HISTORIC AND DESIGN REVIEW COMMISSION

June 05, 2019

HDRC CASE NO: 2019-279
ADDRESS: 133 W CRAIG PLACE
LEGAL DESCRIPTION: NCB 1860 BLK 1 LOT 21
ZONING: MF-33,H
CITY COUNCIL DIST.: 1
DISTRICT: Monte Vista Historic District
APPLICANT: Carolanne Bright
OWNER: Carolanne Bright
TYPE OF WORK: Window replacement
APPLICATION RECEIVED: May 15, 2019
60-DAY REVIEW: July 14, 2019
CASE MANAGER: Stephanie Phillips

The applicant is requesting a Certificate of Appropriateness for approval to replace historic one over one wood windows with new vinyl windows. 6 windows are located in the primary structure and approximately 16 windows are located in the carriage house.

D
A-1 CARRIAGE HOUSE 1st FLOOR
1/4" = 1'-0"

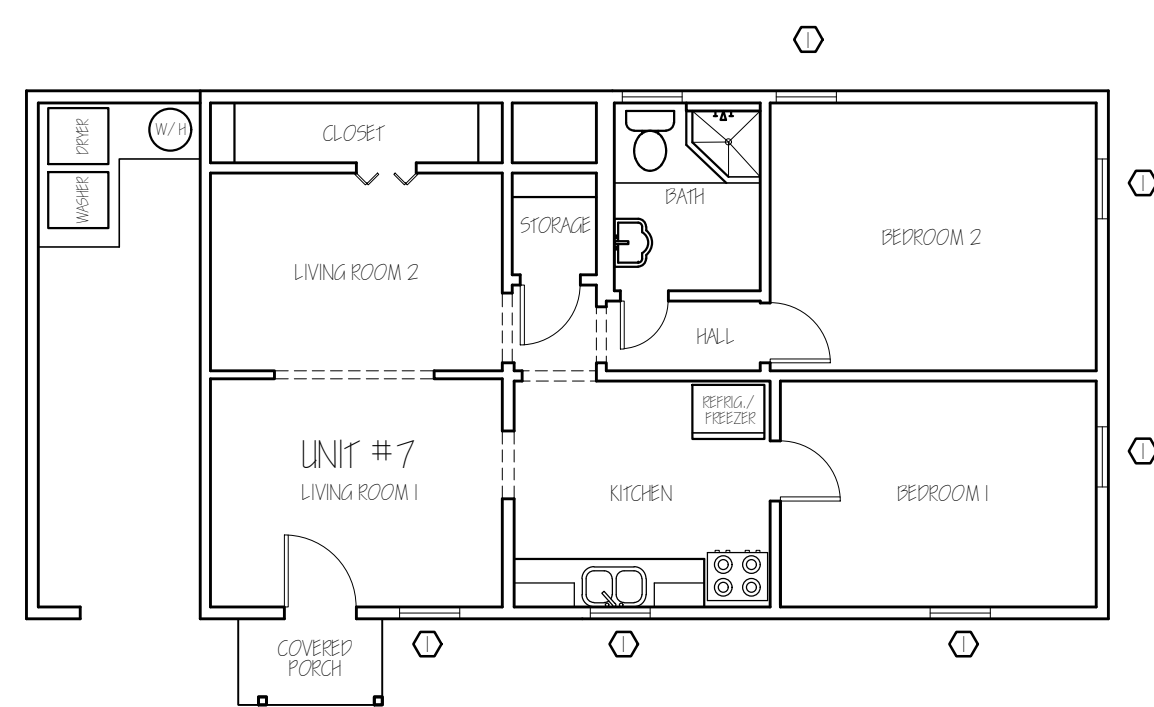
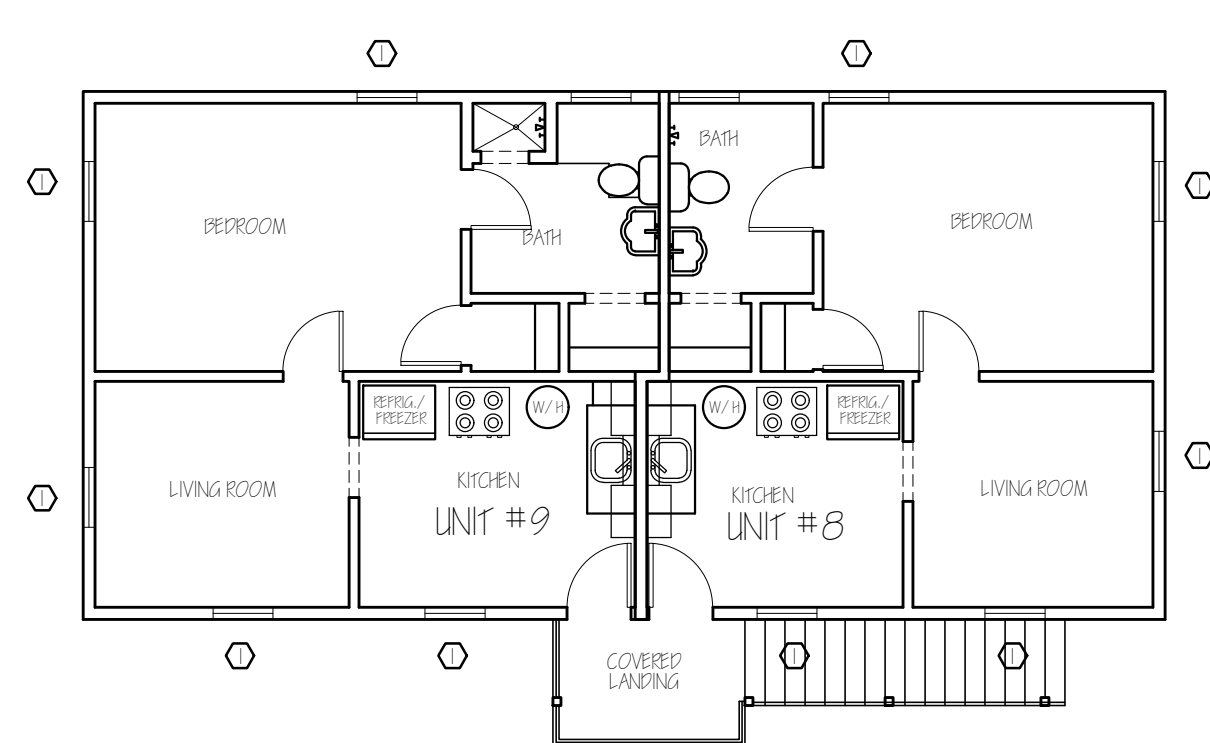
- b. **EXISTING WINDOWS: CONDITION** – The applicant provided several photographs of the existing windows taken from outside the structures. Many of the windows feature exterior wood screens which have helped protect the window assemblies from ample sun exposure and other environmental factors. The applicant has noted that some of the windows are not operable, have broken or missing pulley cords, and are drafty. Based on the photographic evidence provided, staff finds that a majority of the windows are in good condition and are fully repairable. Staff finds that window number 5 on the rear accessory structure as indicated on a photograph submitted by the applicant is eligible for replacement due to significant deterioration from the installation of a window unit. At this time, based on the evidence provided, staff finds that all other windows can be repaired.

- d. **WINDOW REPLACEMENT** – According to the Guidelines for Exterior Maintenance and Alterations 6.A.iii., and 6.B.iv., in kind replacement of windows is only appropriate when the original windows are beyond repair. As noted in finding b, staff finds one window to be deteriorated beyond repair, but does not find the rest to be unrepairable. Replacement of any kind is not consistent with the Guidelines.

Staff recommends approval of the replacement of window #5 on the rear accessory structure based on finding b with the following stipulation:

- i. That the applicant installs one-over-one wood windows to match the existing configuration as closely as possible. Vinyl or composite windows are not appropriate. Meeting rails must be no taller than 1.25” and stiles no wider than 2.25”. There should be a minimum of two inches in depth between the front face of the window trim and the front face of the top window sash. This must be accomplished by recessing the window sufficiently within the opening or with the installation of additional window trim to add thickness. The final specification should be submitted to staff for review prior to the issuance of a Certificate of Appropriateness.
